# TECHNICAL NOTE 1

**SUBJECT:** A14 NMU Routes BN18 and BN22 Safety Reviews

**PROJECT:** A14 NMU Bridges

Figure 6- Swavesey South Location Plan

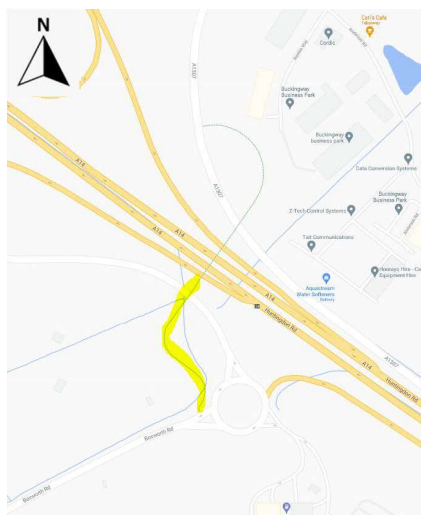
On the Swavesey south route, the gradients are more gentle and the route leads to an uncontrolled crossing via a 90-degree bend. At the tie in to Boxworth Road, there are wayfinding signs for pedestrians, cyclists and horse riders, but the shared signs leading to the NMU bridge is only signed for pedestrians and cyclists. It is therefore unclear whether horse riders are expected to use the bridge.

Cyclists descending the ramp at Swavesey south have good visibility to approaching cyclists/ pedestrians and will be slowing down to the crossing due to the 90-degree bend. The risk of collision with other pedestrians/cyclists and vehicles at this location is low.

It is recommended that the chicane barrier arrangement at this location is removed. It is also recommended that a form of vehicle access control is provided to prevent unauthorised vehicles from accessing the NMU route.

Figure 9 – Bar Hill North Location Plan

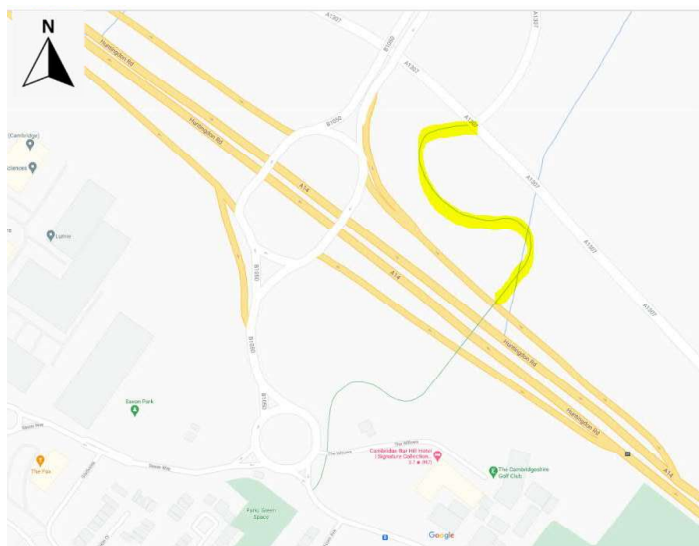
The NMU route over the A14 at its northern end joins the existing road (A1307) parallel to the A14 via a controlled crossing.

The slope on the northern approach ramp is gentle and unlikely to encourage higher cyclist speeds. The visibility to other approaching cyclists/ pedestrians is generally good. There is a wide verge serving as a buffer zone between the NMU route and the carriageway. The risk of speed and collisions with other pedestrians/cyclists or vehicles at this location is low.

It is recommended that the chicane barrier arrangement at this location is removed. It is also recommended that a form of vehicle access control is provided to prevent unauthorised vehicles from accessing the NMU route.

Figure 12 – Bar Hill South Location Plan

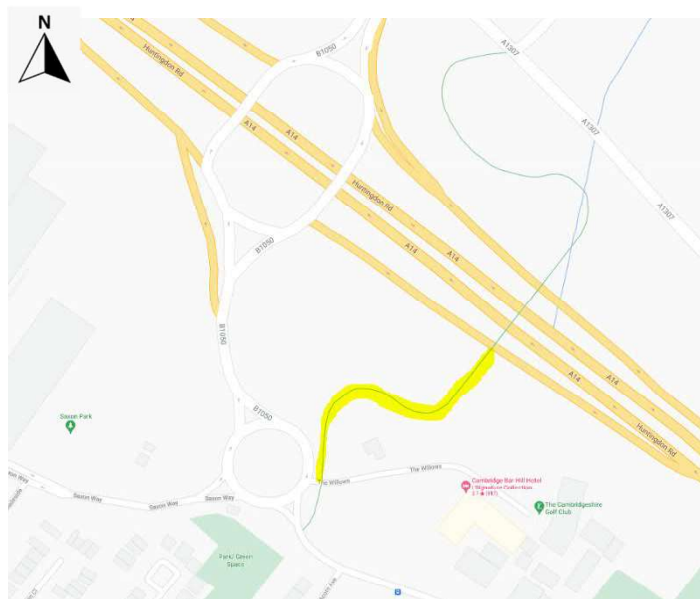
South of the NMU bridge, the alignment of the route follows a series of horizontal curves and gradients along this section appear to be steep (LTN 1/20 recommends a desirable maximum length of 30m for a 5% gradient). The edge of the NMU route is protected by a high fence infilled with mesh. Visibility along this section of the route is restricted by the horizontal curvature and fence. There is no visibility to other approaching cyclists/pedestrians or horse riders and there is an increased of conflict between cyclists and pedestrians/other cyclists and horse riders. Any conflicts between cyclists/pedestrians/horse riders is likely to occur within this section.

Visibility as the route approaches the Willows is generally good although it is partially obstructed by a large sign and overgrown vegetation in the northern verge of The Willows.

At the location of the southern barrier, cyclists will generally have good forward visibility to traffic however visibility to vehicles exiting The Willows is obstructed by the hotel sign and overgrown vegetation. Risk of collision with vehicles or other cyclists/pedestrians is low.

- The chicane barrier arrangement is removed.
- A form of vehicle access control is provided to prevent unauthorised vehicles from accessing the NMU route.
- The hotel sign in the northern verge of The Willows is set further back and overgrown vegetation cut back to improve visibility to vehicles exiting The Cambridge Bar Hotel.
- Cycle logos are installed on the outside of the bend on the downward grade where visibility is poor to encourage cyclists to keep to the edge of the NMU route thereby minimising conflict with other users.
